State of California
AIR RESOURCES BOARD

FINAL STATEMENT OF REASONS

**AMENDMENTS TO THE LEV III CRITERIA POLLUTANT
REQUIREMENTS FOR LIGHT- AND MEDIUM-DUTY VEHICLES, THE
HYBRID ELECTRIC VEHICLE TEST PROCEDURES, AND THE HEAVY-
DUTY OTTO-CYCLE AND HEAVY-DUTY DIESEL TEST PROCEDURES**

August 2015

Figure 4

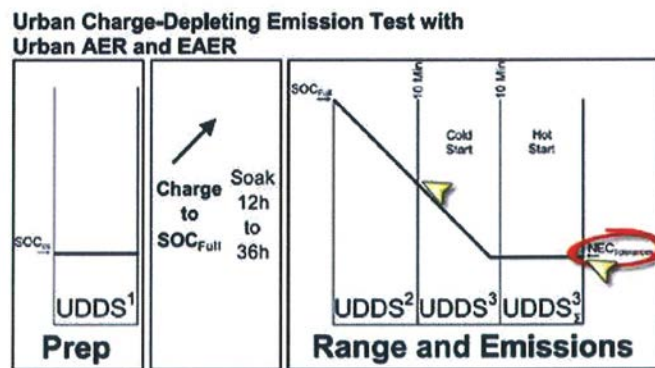
165. Comment: G.5.4.2.17 (page A-57) Primary EOT Criterion. We believe the definition of Initial and Final Amp-hour in the text is a mistake, because it conflicts with p. A-50 paragraph 8, p. A-52 5.2.8, and p. A-73 Figure 4. Paragraph 5.4.2.17 lists the primary EOT criterion as $\leq 1\%$ NEC from the beginning of the first cycle to the end of the second cycle. However, this ignores any additional hot-start cycles driven after the first 2 cycles and cannot possibly be satisfied for a charge-depleting test. Paragraph G.5.4.3.1 lists additional EOT criterion as SAE J1711 section 3.9 with permission of Executive Officer. SAE J1711 section 3.9 is the same as paragraph G.5.4.2.17 but considers the NEC over the last cycle or set of cycles, not the first 2 cycles. This additional EOT criterion (not the primary criterion) is what is shown in Figure 4. We recommend changing the paragraph G.5.4.2.17 definition of beginning and end SOC to match SAE J1711 section 3.9. Since this is primary EOT criterion, it does not require permission of Executive Officer. Then the Additional EOT criteria (which need permission) can be 1) SAE J1711 3.9.1, and 2) Final SOC > Initial SOC. (Steven Douglas, Senior Director, Environmental Affairs,

This start and end point is a carryover from HEV testing and cannot possibly be fulfilled in a charge-depleting test unless the engine turns on immediately at the beginning of the first cycle.

As shown by the two arrows indicating initial and final Amp-hr, even the example test shown in Section I Figure 4 does not fulfill this primary criterion. Additionally, the end point being identified as "NEC_{Tolerances}", as opposed to "NEC_{options}", indicates that no additional end-of-test criteria may be used to validate this test.

FIGURE 4 - SEVERAL SCENARIOS OF EOT CRITERION

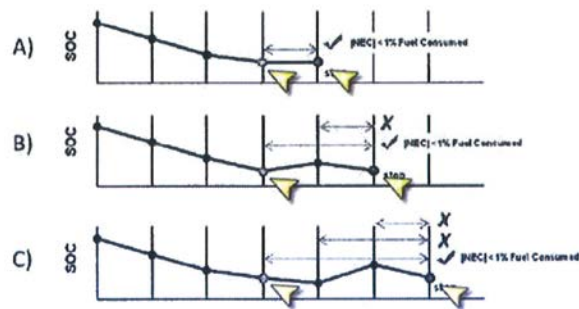
Given that this test allows more than two cycles, the primary end-of-test criterion also ignores any cycles driven after the first two.

We propose that the primary end-of-test criterion be changed to apply over the last cycle or set of cycles, as described in p. A-50 paragraph 8 for compliance and in-use testing. This also follows the spirit of the end-of-test criteria described for charge-depleting tests in SAE J1711 sections 3.9 and 3.9.1, shown here:
